**RE: Response to EDQ Further Issues - Carseldine Urban Village Stage 2**

Carseldine Urban Village – Stage 2

17BRA0109 R03\_3 - Stage 2

Figure 6: Predicted Rail Noise Levels Compared to SDAP Outdoor Criteria - No Acoustic Barriers

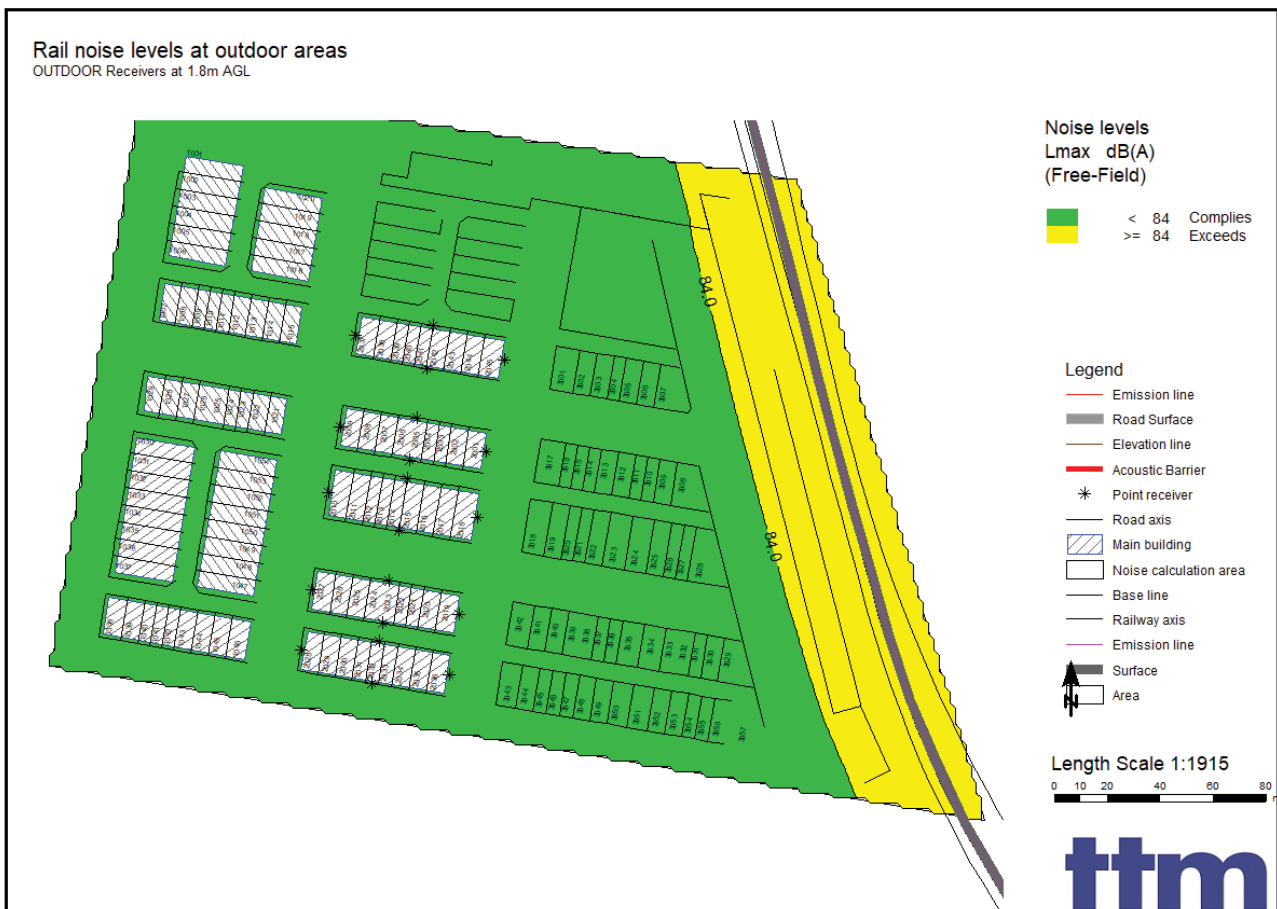
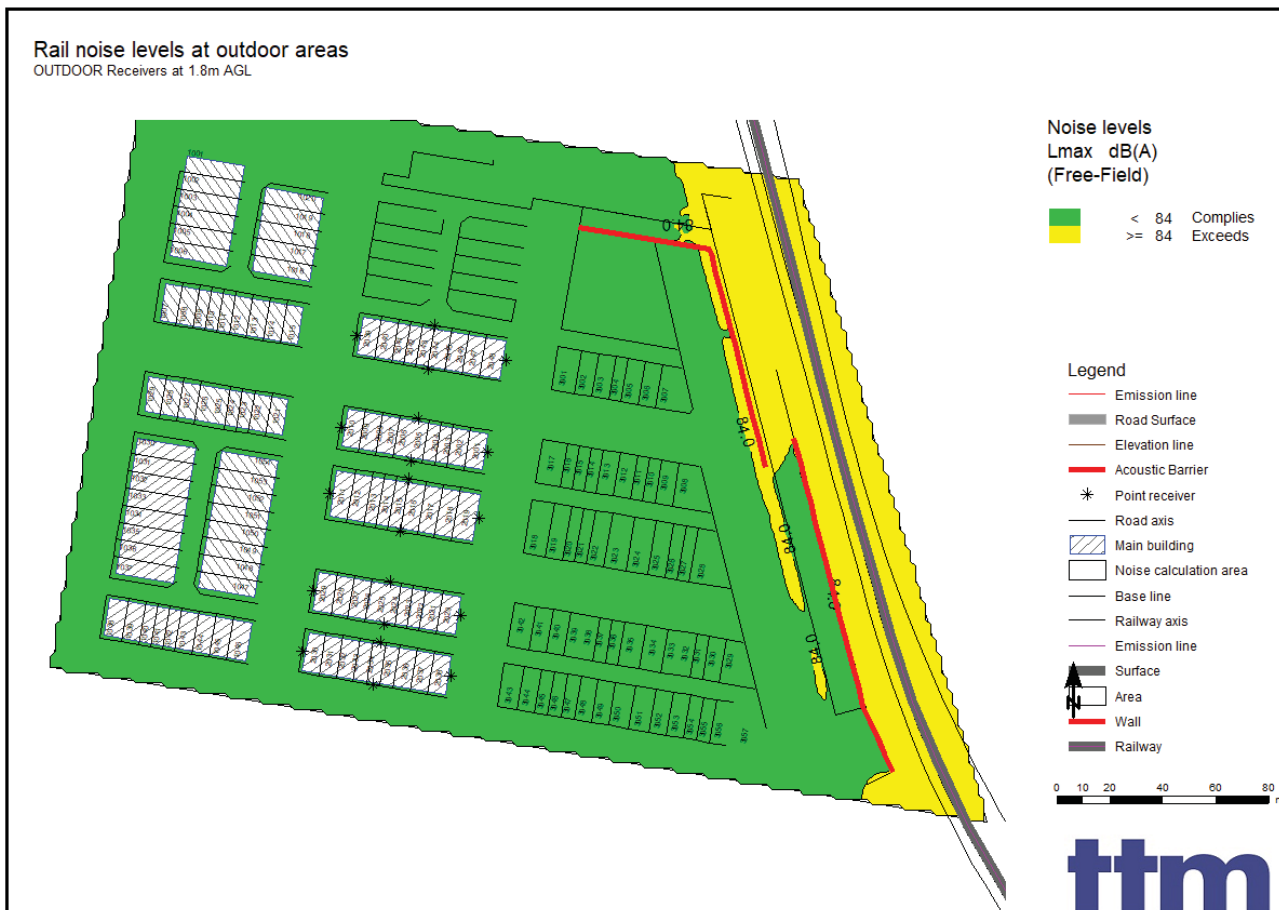
*Please provide rail noise predictions with and without noise barriers.*

The revised acoustic report includes assessment with and without noise barriers and demonstrates compliance with State Development Assessment Provision (SDAP) noise criteria for the proposed acoustic barrier.

Revised Rail Noise Acoustic Barrier (used in the noise model)

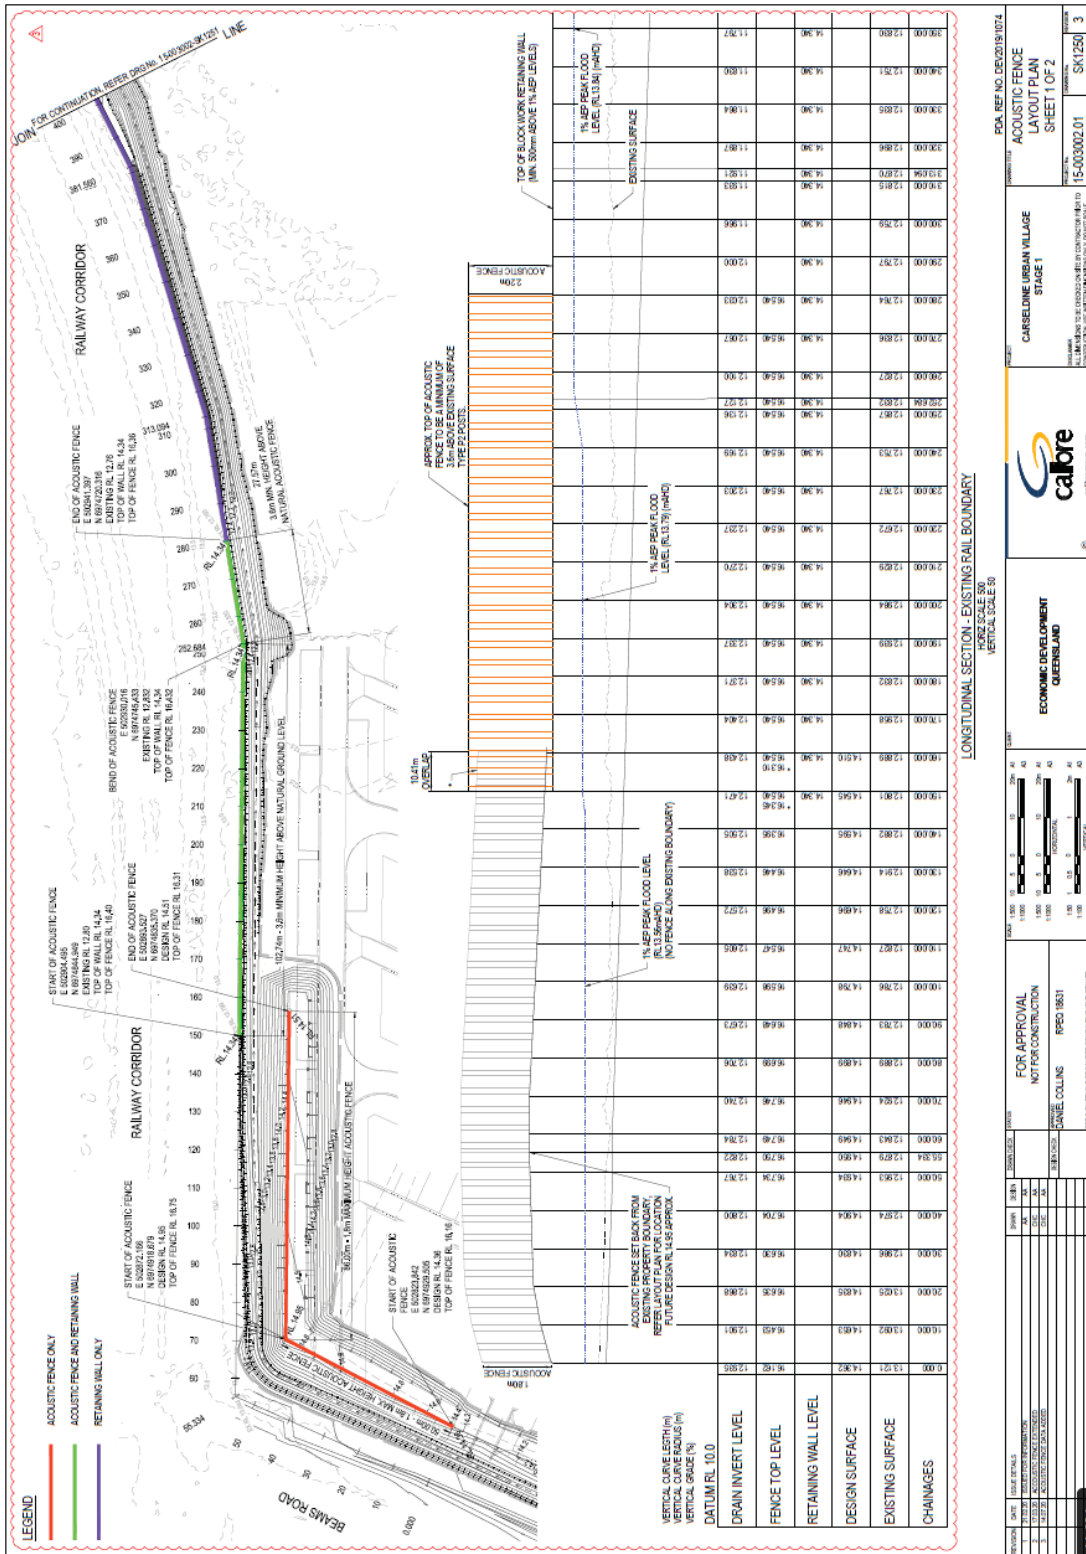
*Design noise barriers to comply with the relevant external noise criteria on all stages and lots.*

*The report shall specify the barrier heights and Reduce Levels (RL's) for the top edge of the required noise barriers at the corners of barriers, the end of noise barriers, any change in barrier height and at spacing no greater than 10m apart.*

*Barriers should have sufficient overlap, recommend an overlap of at least 4 times the width of the gap in the barriers*

The proposed acoustic barrier complies with the relevant SDAP noise criteria for all stages and all lots.

The acoustic report includes all barrier height details in Appendix A.

The noise modelling results show that the proposed acoustic barrier overlap is acceptable.
